Wizards Workshop

Published by Service Admin Support

October 9, 1981
Issue 11-19

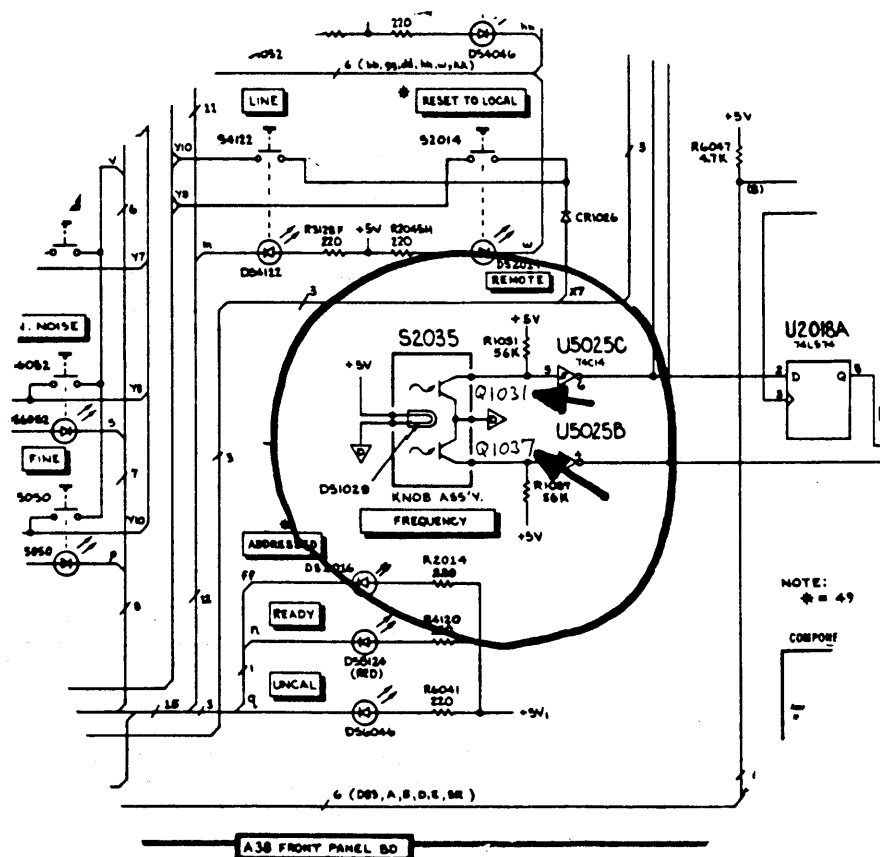
An 040-1007-00 up-date kit has been set-up to improve sensitivity in the 492. The modification kit contains the parts and instructions to add electrical shields to the A62 Log and Video Amplifier circuit board and the A51 Phase Lock Control circuit board.

Use of the new electrical shields necessitates replacing the A50 and A51 circuit board holders to provide mounting for the new shields.

At the same time, a grounding plate is added between the A50 Phase Lock Synthesizer and the A51 Phase Lock Control circuit board.

1421/1422 EXTERNAL SUBCARRIER LIGHT

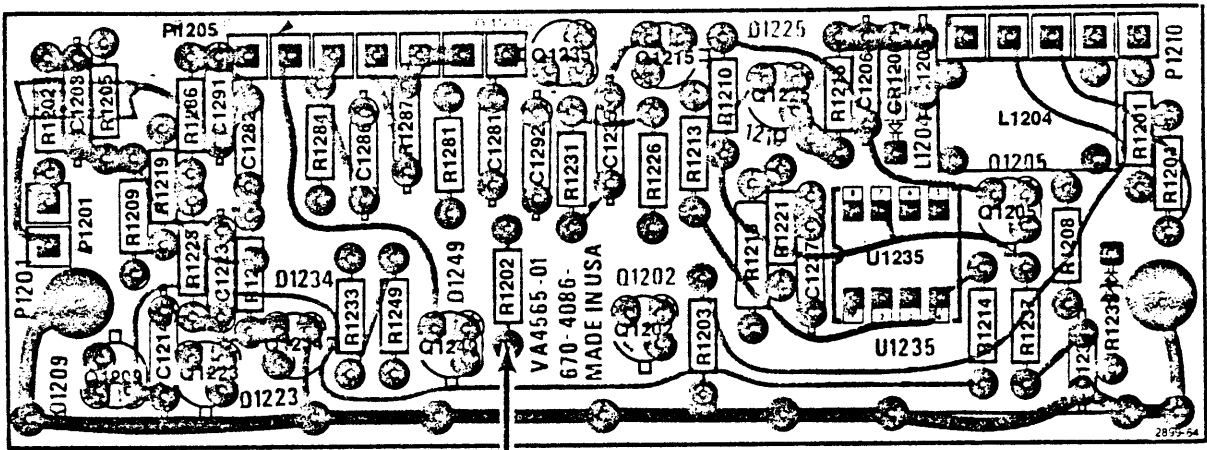
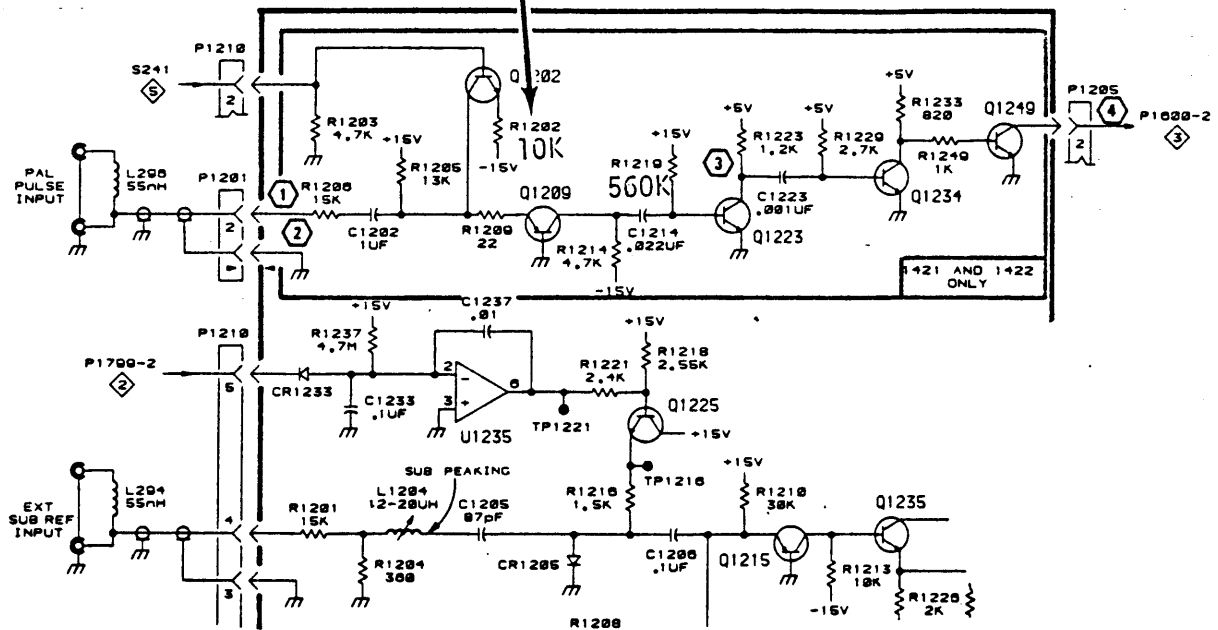
A few instances have been observed where the External Subcarrier light will not turn completely off when S241 is placed in either NTSC position and the INT/EXT SUB switch is set to the EXT position.

Correct Circuit Number to R1207 315-0622-00 6.2K
315-0103-00 10K

To insure complete turn-off, change R1207 to a 10K (315-0103-00) resistor. Note that the circuit number in the electrical Parts List doesn't match the schematic and board lay-outs. The circuit number on the schematic and board layout should be R1207, not R1202.

Exploded Views

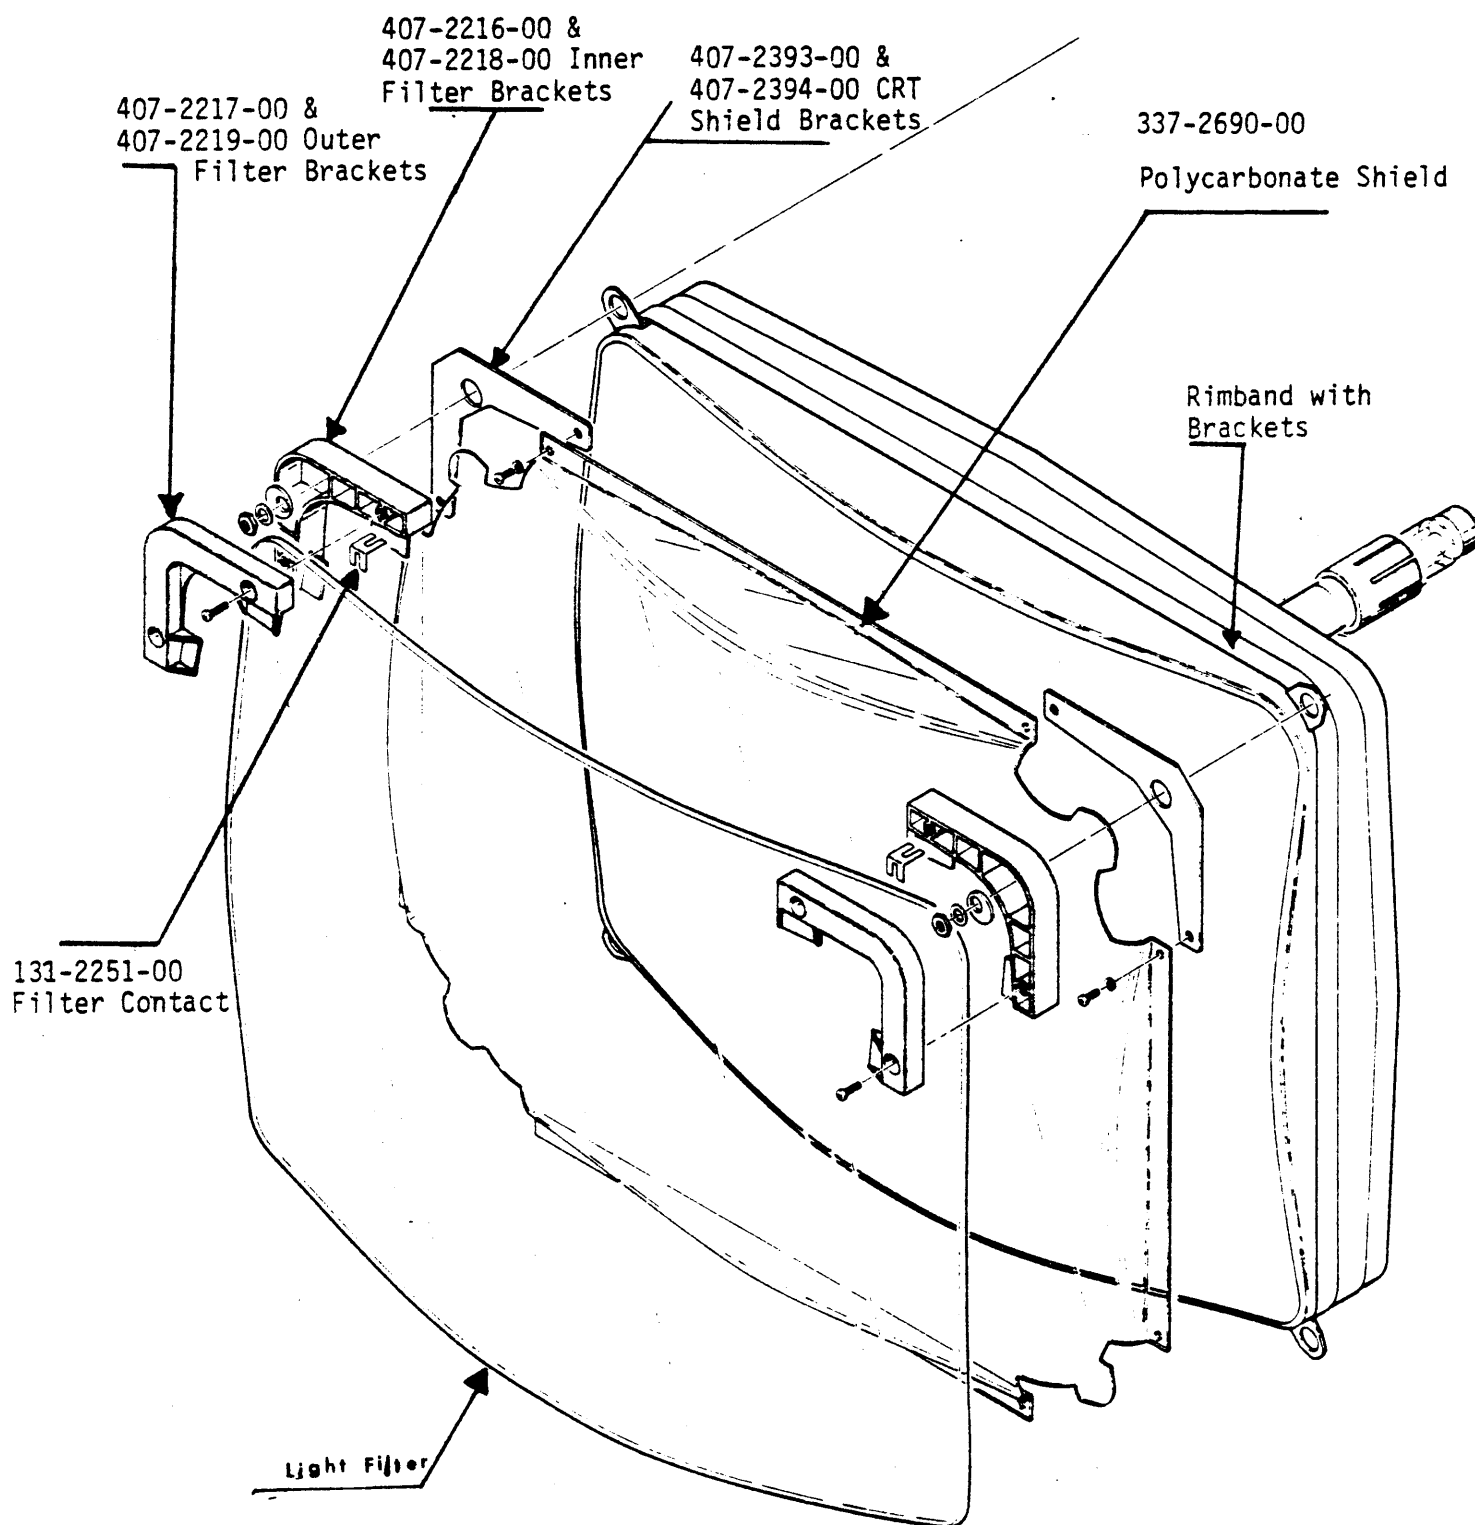
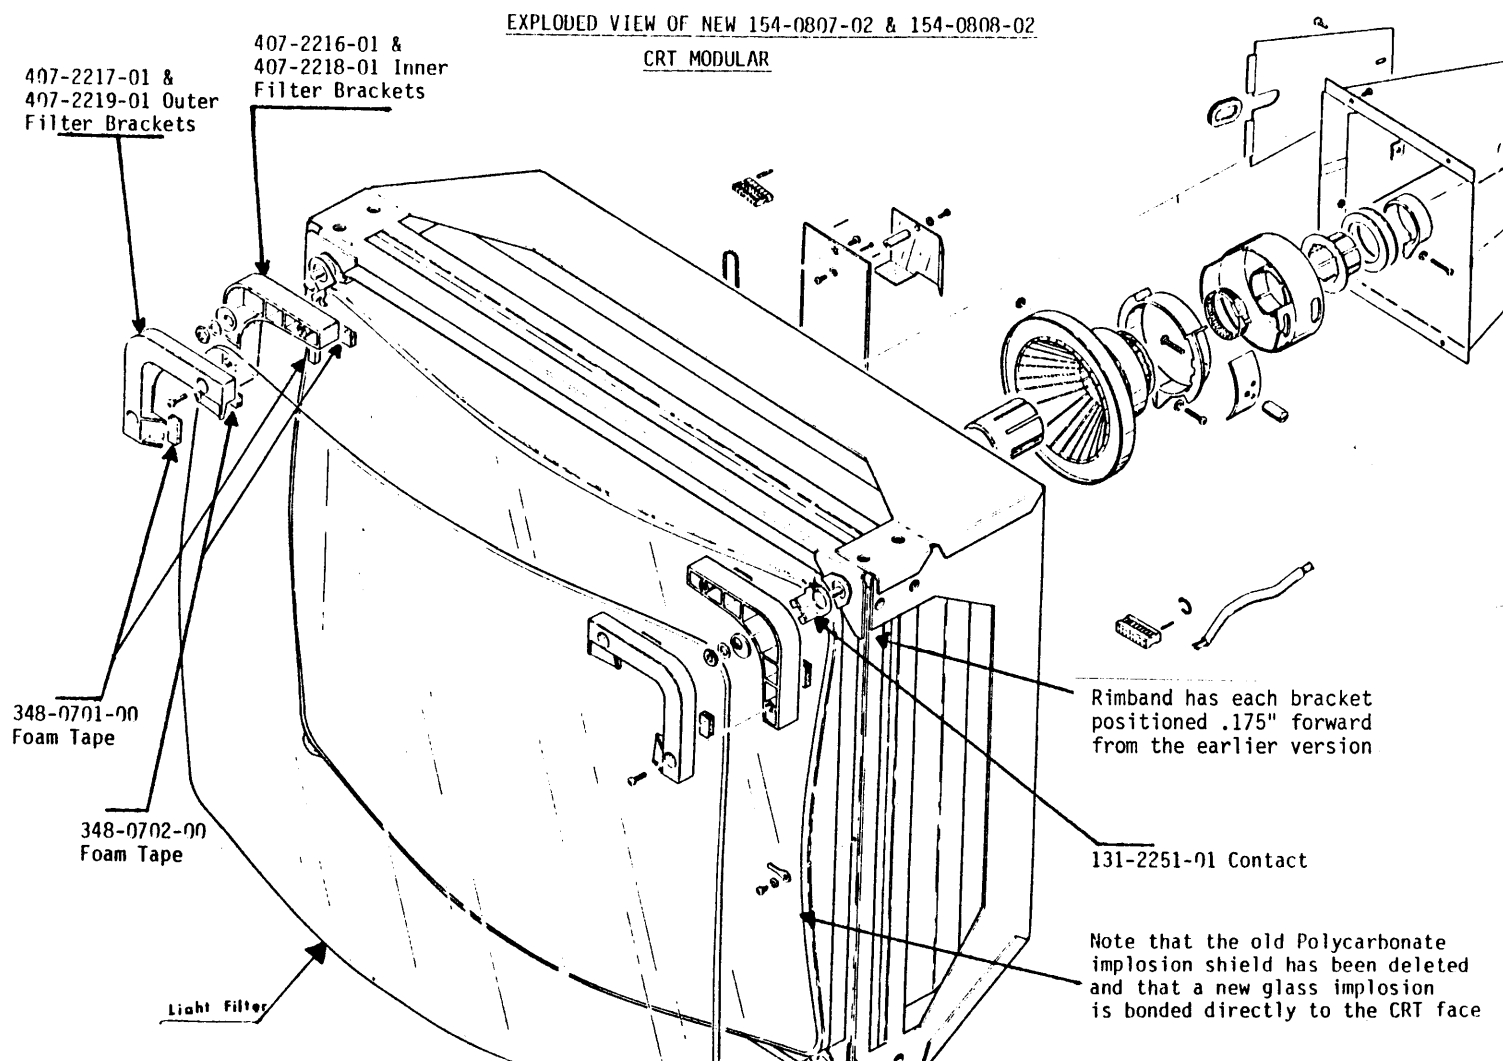
With the additional thickness of the bonded glass shield, the CRT had to be moved back $\frac{3}{8}$ of an inch to the rear causing the CRT JEDEC headers to be very close to the mu-metal shield wall. This could cause an electrical shorting problem unless additional space and insulation are provided. Therefore, the mu-metal shield was modified to add dimples to allow for new insulator heads that were designed to insulate the JEDEC headers.

The attached exploded views show both the old and new versions. Note the part numbers and part names. Also note the placement of parts, especially the rubber cushions for the Light Filter. Notice that the brackets have a long and short edge. Be sure to orient them correctly when installing a new CRT module. The long edges should be in a horizontal direction.

FIGURE 1
Component Locations

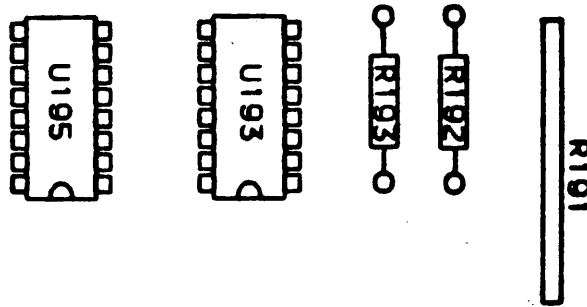
1. Remove and replace U473 (8202) with an 8202A. See Note 1.
2. Remove U193 (74S74). See Note 1.
3. Insert R192 and R193 (131-0566-00, 0 ohm resistors) as in Figure 1.
4. Roll the 670 from -00 to -02 . Add 672-0950-02 sticker.

1. Remove and replace U473 (8202) with an 8202A. See Note 1.
2. Remove U193 (74S74) and piggyback (74S04). See Note 1.

3. Insert R192 and R193 (131-0566-00, 0 ohm resistors) as in Figure 1.
4. Roll the 670 from -00 to -02. Add 672-0950-02 sticker.

FIGURE 2
Component Locations

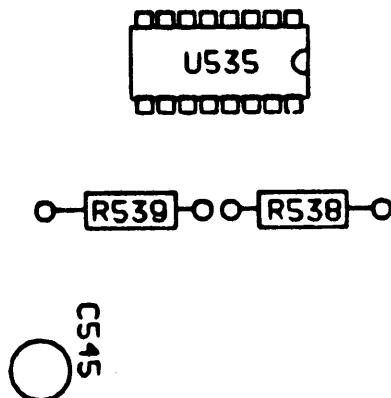
- A. If U535 does not have a piggyback IC.
 1. Remove and replace U451 (8202) with an 8202A. See Note 1.
 2. Remove U535 (74S74). See Note 1.
 3. Insert R538 and R539 (131-0566-00, 0 ohm resistors) as shown in Figure 2.
 4. Roll 670-6669-00 to 670-6669-02 and skip step B.
- B. If U535 has a piggyback IC.
 1. Remove and replace U451 (8202) with an 8202A. See Note 1.
 2. Remove U535 (74S74) and piggyback (74S04).

3. Insert R538 and R539 (131-0566-00, 0 ohm resistors) as shown in Figure 2.
4. Roll 670-6669-01 to 670-6669-02.

Figure 3
Edge Connectors With Runs between J32 and J34

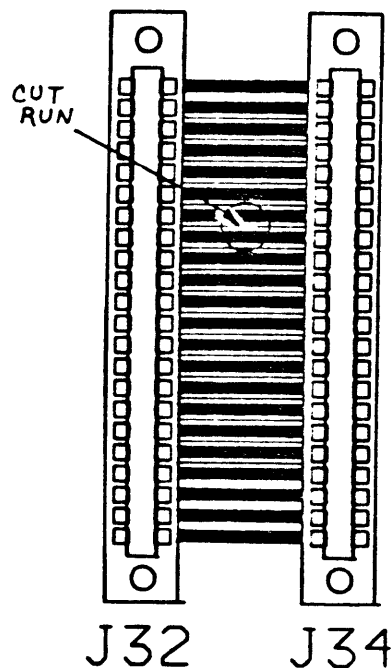
1. Open card cage and remove any cards that are installed in J30, J32 and J34, which are 44 pin connectors on the Raster Bus.
2. Insert an extender board in J34.
3. Connect an ohm meter to pin 30 of the extender board. Use the other lead to verify which run between J32 and J34 must be cut. It is the 13th run from the top and is a narrow run between two wider runs. See Figure 3.
4. Cut the run with a sharp knife being careful not to damage any other runs.
5. Check for an open between pins 30 of J32 and J34.
6. Reinstall the cards removed from the card cage and close up instrument.

Figure 4
Location Of Cut Run On Back Of Board

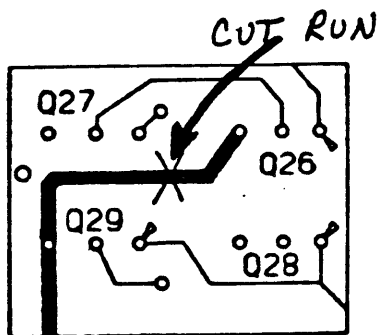
1. Replace C114 with a 0.22uf capacitor (283-0423-00).
2. Cut the run between Q29 collector and Q26 collector on back side of board. See Figure 4.
3. Add the 3-terminal +5V regulator, U117, (156-0991-00) to the front side of the board, as in Figure 5.
 - a. pin 1 to C114
 - b. pin 2 to R115
4. Add the 0.1uf (C117) capacitor between pin one of U121 and pin 3 of the 5V regulator (U117) just installed.
5. From the junction of pin 3 of U117 and C117 run a mod wire to the bottom of the board to C642. Run the mod wire under the grounded stiffener bar to help hold it close to the board.

Figure 1. Power Supply Schematic, Sheet 1 (partial)

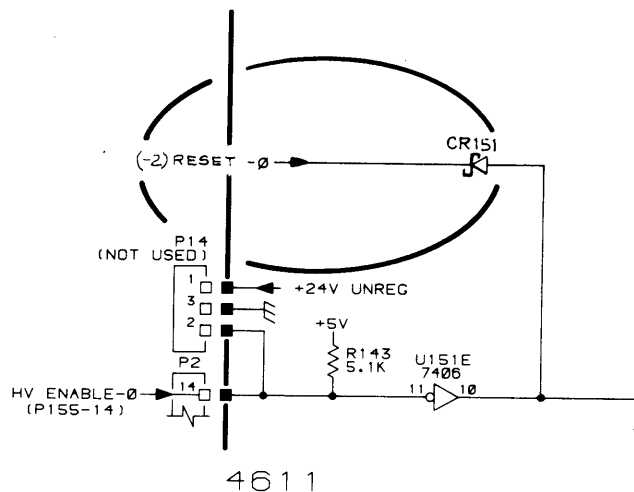
1. R193 and R195 changed to 75 ohm, p/n 315-0750-00, to increase encoder LED current.
2. CR151 p/n 152-0322-00 was added to the back of the the board. See Figure 1.
3. Encoder detect and pulse shaping circuit was changed extensively with a hand-add. See Figure 2.

CHANGE AS SHOWN:

Figure 3. Power Supply Schematic, Sheet 2 (partial)

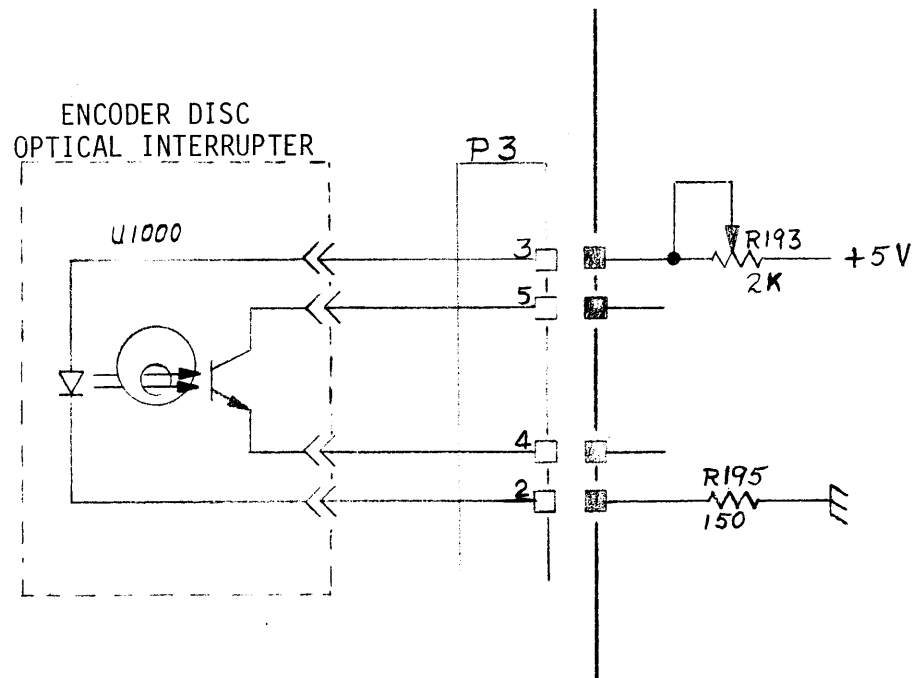
1. R195 was changed to 150 ohm, p/n 315-0151-00; R193 was changed from a fixed resistor to a 2K pot, 311-1918-00, hand-add. See Figure 3.
2. New adjustment procedure for R193:
 - a. Turn on the hard copy unit and allow to warm up (copy light steady).
 - b. Connect a voltmeter between ground and the collector of Q191 (junction of R197 which is a 10K resistor, and C191 which is a 4700 pF capacitor).
